BP 43/83--Amdt. #1-I

Subject: Approved amendment to building permit involving alterations of building at the corner of Island Avenue and Welch Street, Peaks Island, to increase the capacity in persons of a place where food or drink is to be sold for consumption there (classified under Building Code as Minor Assembly Hall)

Alterations to commercial building at 4 Welch St., Peabody. 2-23-45.  
Chas. Tofford, owner, 134 Conley St. Ch.  
Joseph Farley, lessee, Central Ave. Peabody, Aug. 11, 1945/1077  
Restaurant Alt. 46/545

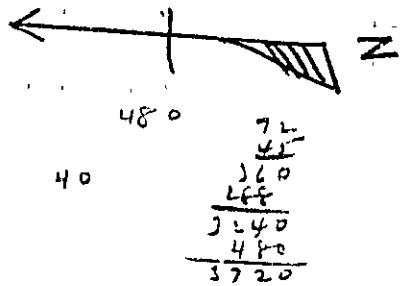
As I told you down town the other day, it does not fall within my duty to tell you how to locate the foundation posts. I am not disposed to quibble over such a minor matter, however.

This looks like the same garage for which I issued a permit to you in 1937, although to judge from the location sketch filed with that application, you must have acquired more land since that time. On the 1937 location you show the garage to be 12' x 24' instead of 12' x 20', setting with the front 78 feet from Welch Street and the rear only 5 feet from the property line in back of the building. You also show a hip roof and the floor joists running across the garage. On this basis you will satisfy the code if there is a 6x8 sill set with two 8 inches upright, as indicated on the old application, by setting cedar posts at each corner, and two intermediate posts under each side, thus making 3 posts in all with the sill on 12' spans front and back, and 8' spans on the sides. For stiffness most good builders would put one additional post in the center under front and rear sills.
